METROPOLITAN GOVERNMENT OF NASHVILLE AND DAVIDSON COUNTY

STAFF RECOMMENDATION 3723 Richland Avenue December 18, 2013

Application: New construction -addition
District: Richland-West End Neighborhood Conservation Zoning Overlay
Council District: 24
Map and Parcel Number: 10409011200
Applicant: Kaitlyn Smous, Allard Ward Architects, LLC
Project Lead: Paul Hoffman, paul.hoffman@nashville.gov

<p>Description of Project: Applicant proposes a rear addition with screened-in porch. An existing rear addition and porch are to be demolished.</p> <p>Recommendation Summary: Staff recommends approval with the conditions:</p> <ol style="list-style-type: none">1. Staff approve brick, stone, windows and doors prior to purchase and installation;2. Staff approve color of metal roof section prior to purchase and installation. <p>With these conditions, staff finds that the project meets Section II.3.B of the <i>Richland-West End Historic Zoning District Handbook and Design Guidelines</i>.</p>	<p>Attachments A: Photographs B: Site Plan C: Elevations</p>
--	--

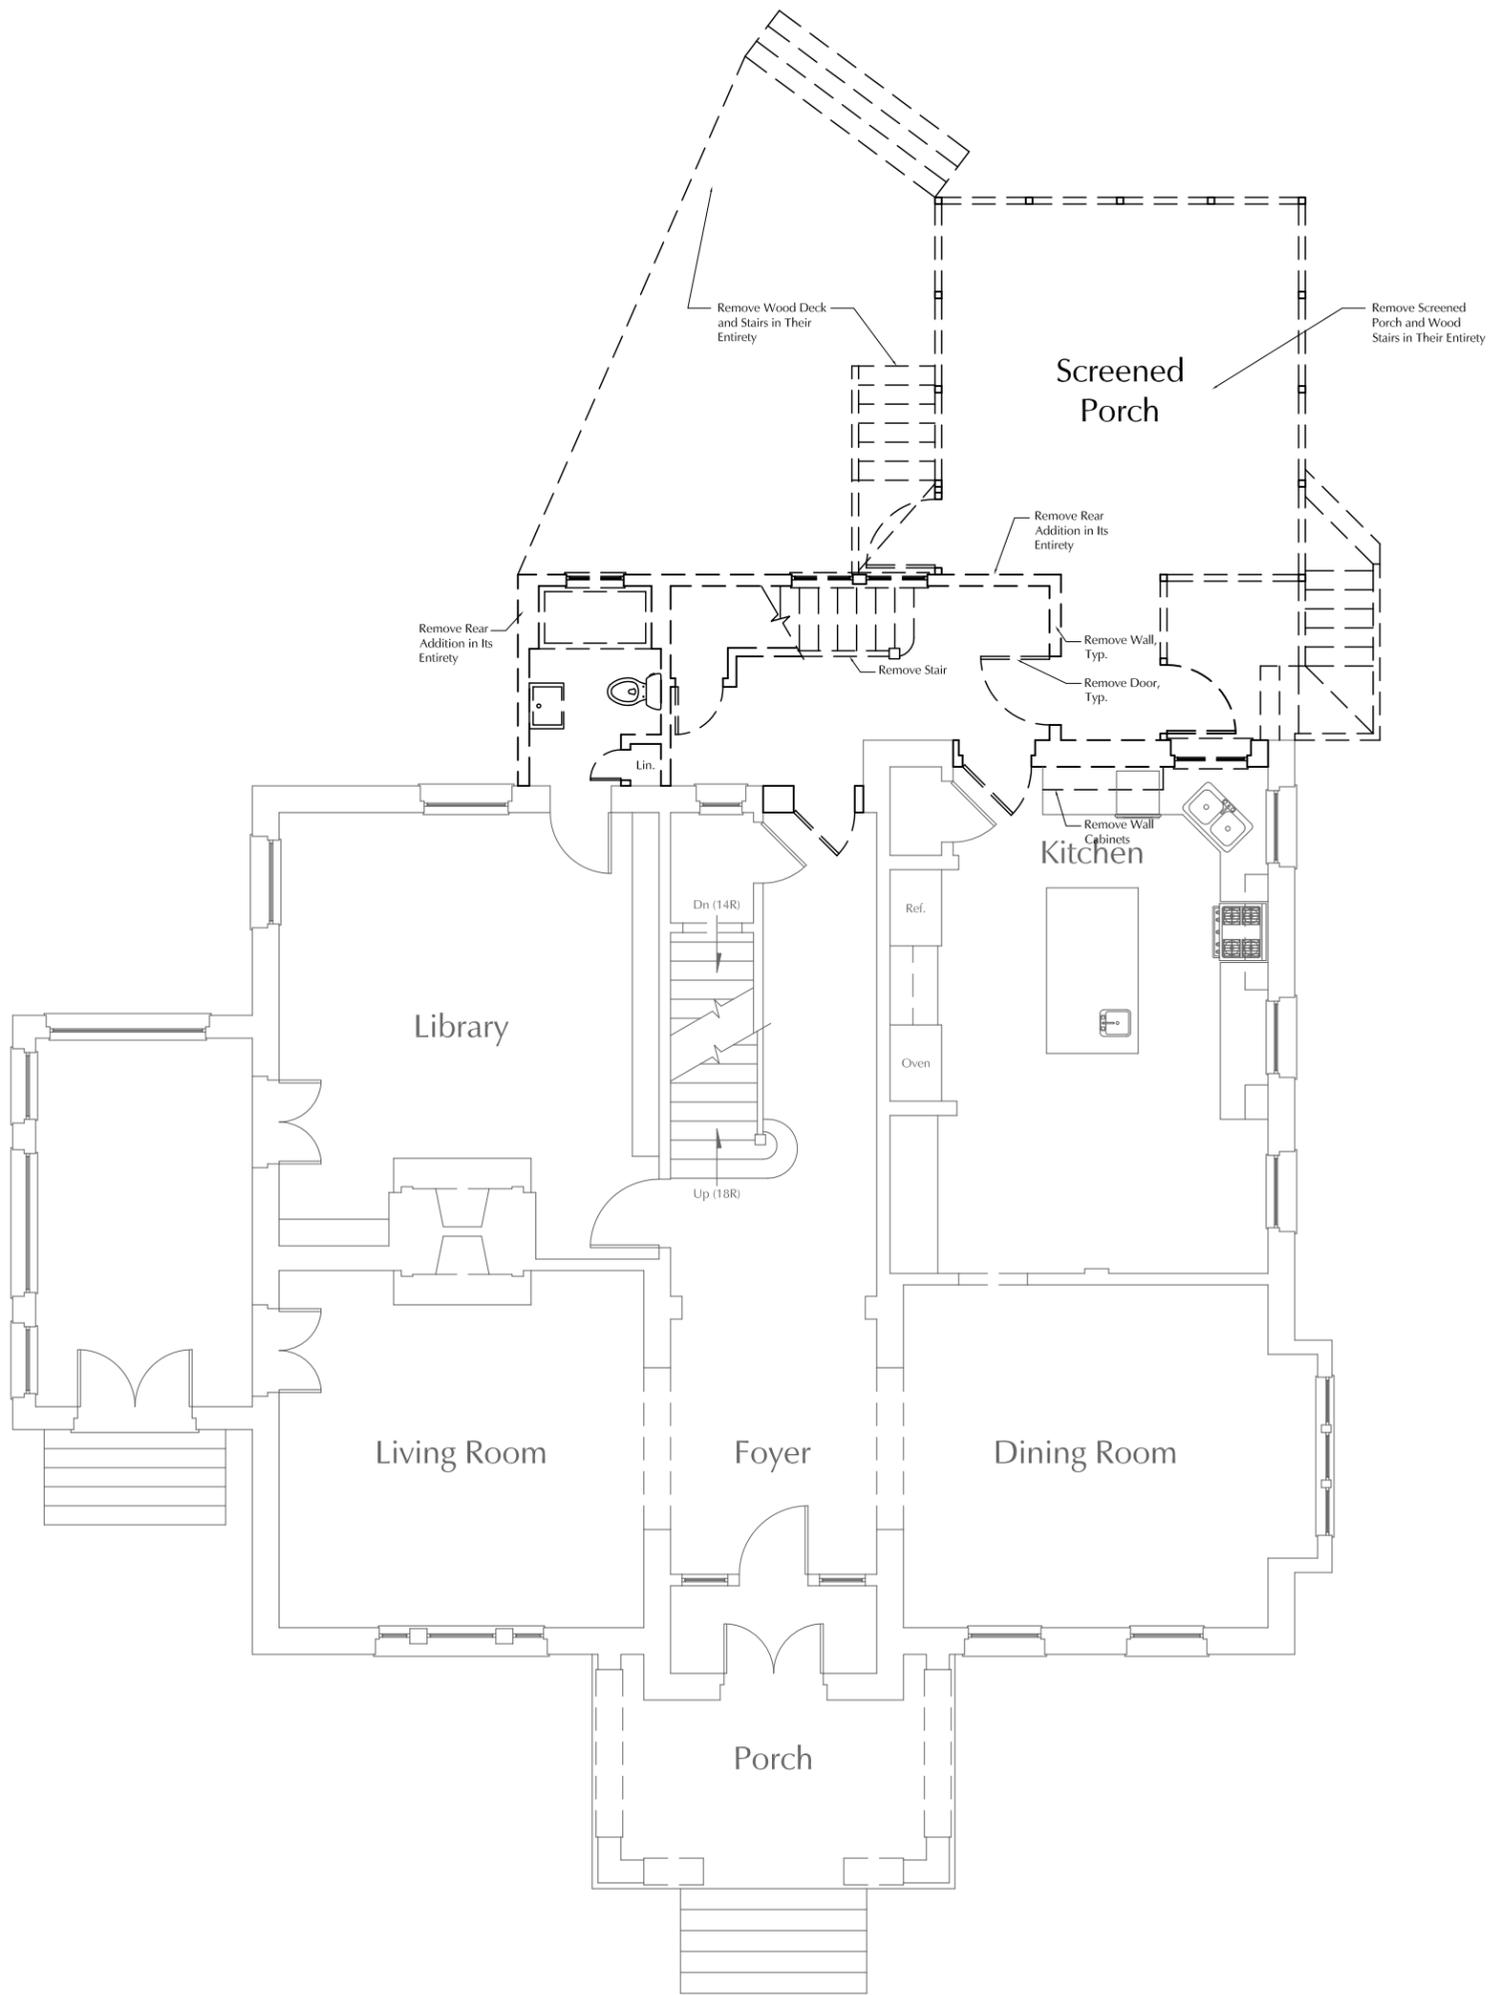
Appurtenances & Utilities: No changes to the site's appurtenances were indicated on the drawings. The location of the HVAC and other utilities was also not noted. Staff asks

that the HVAC be located on the rear façade or on a side façade beyond the midpoint of the house if it needs to be relocated. The project meets section II.B.1.i.

Site Plan

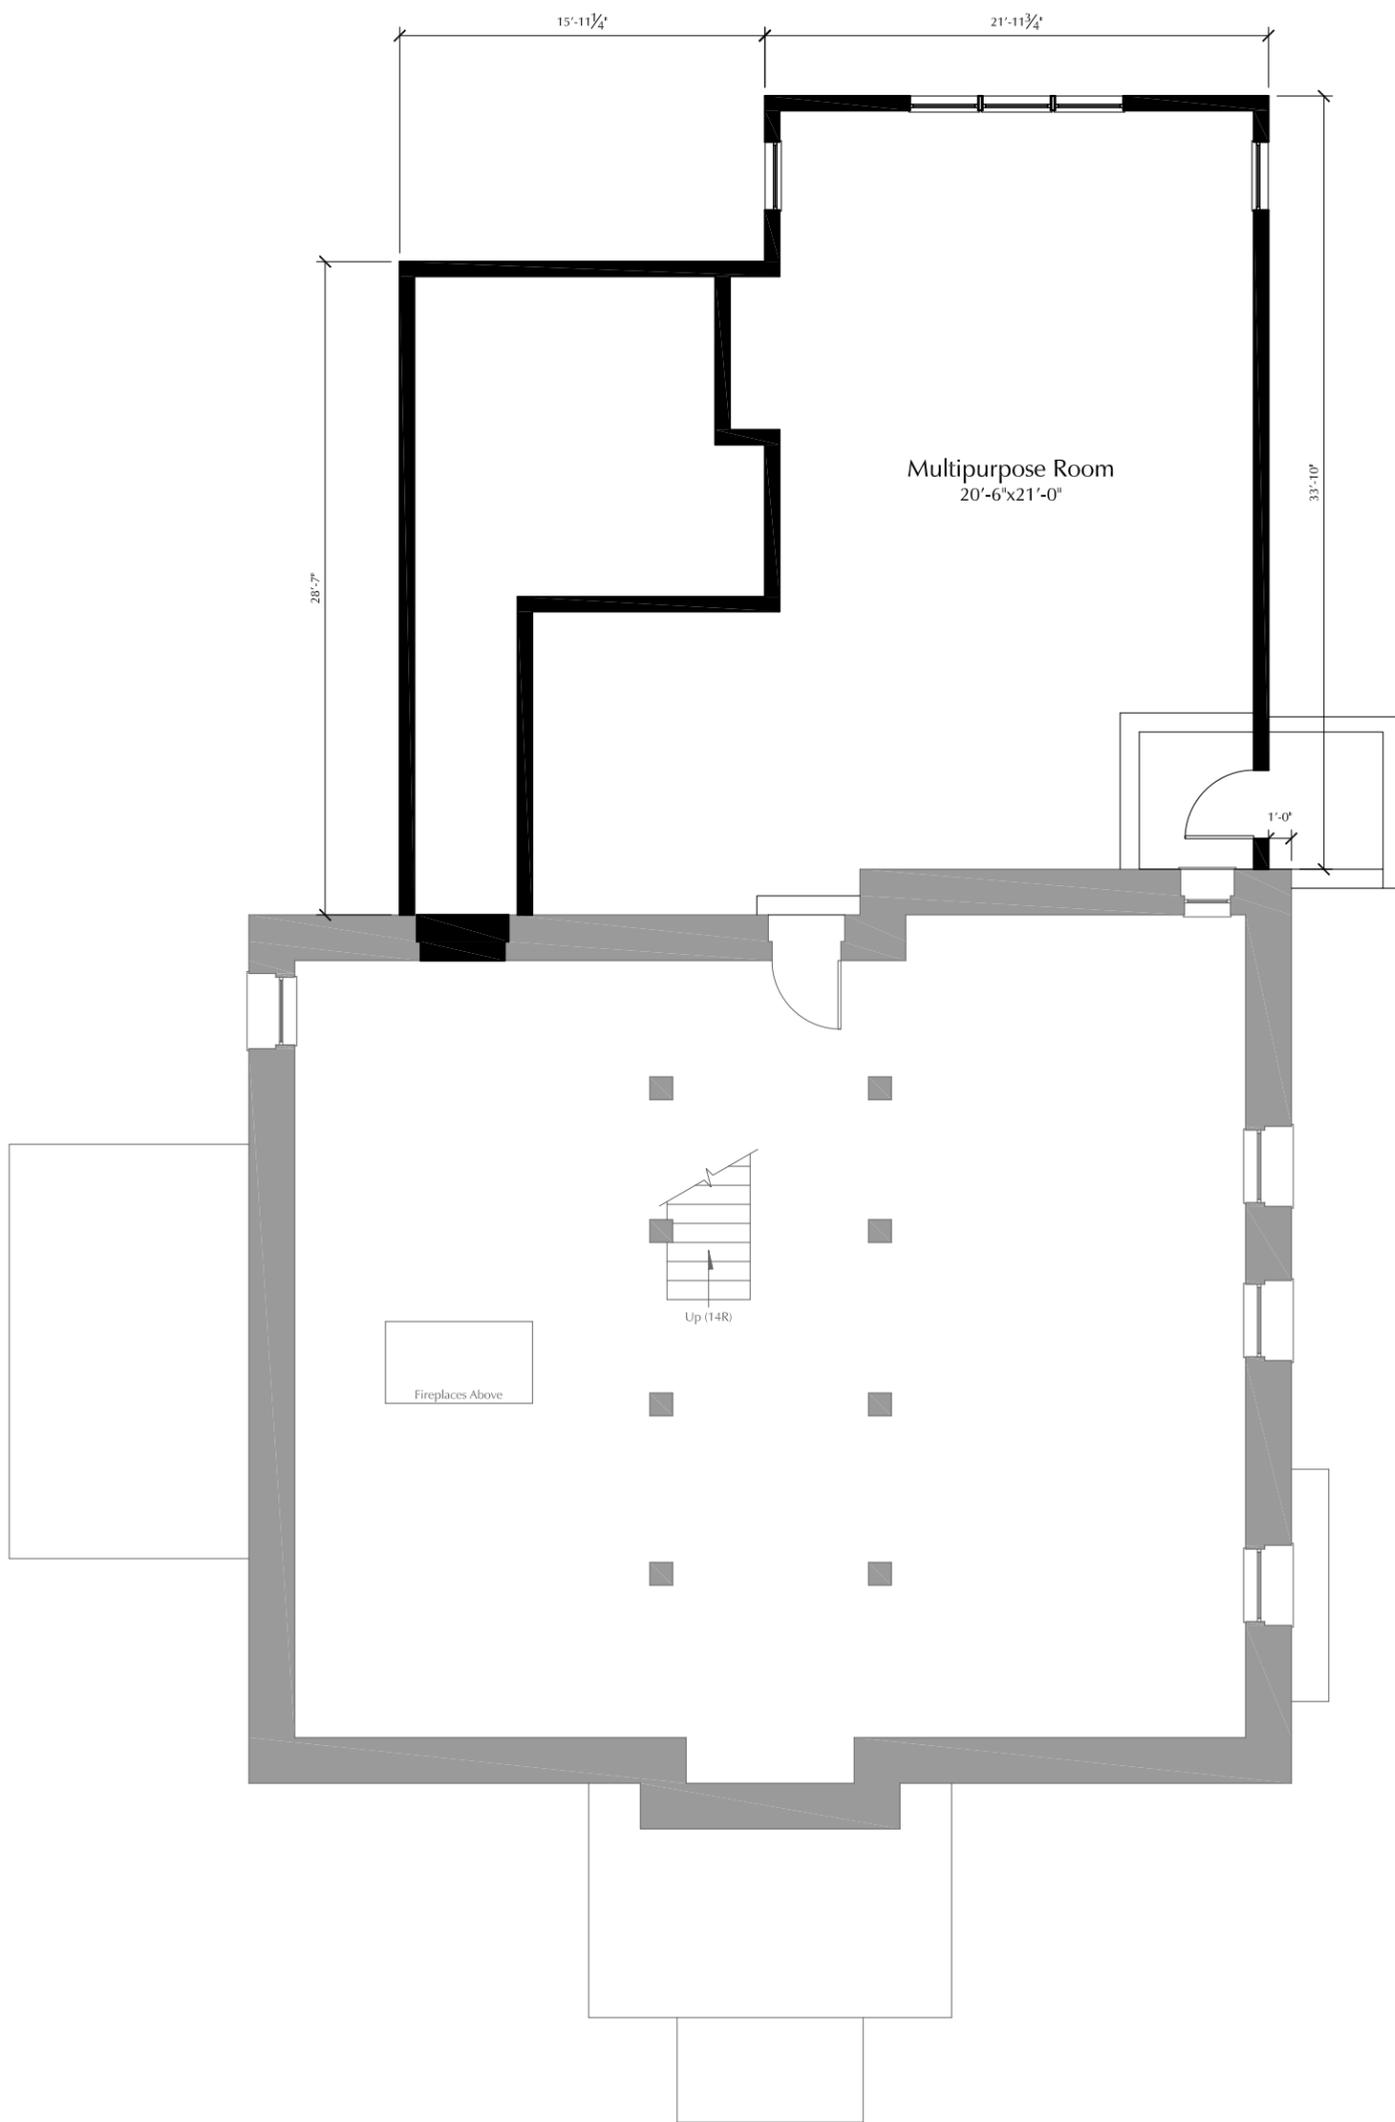
The proposed addition will be sixty-four feet (64') from the rear property line and twenty-five feet (25') from the sides. It meets bulk zoning requirements of twenty feet (20') at the rear and five feet (5') from the sides. It will be minimally-visible from the street. The project meets section II.B.1.c.
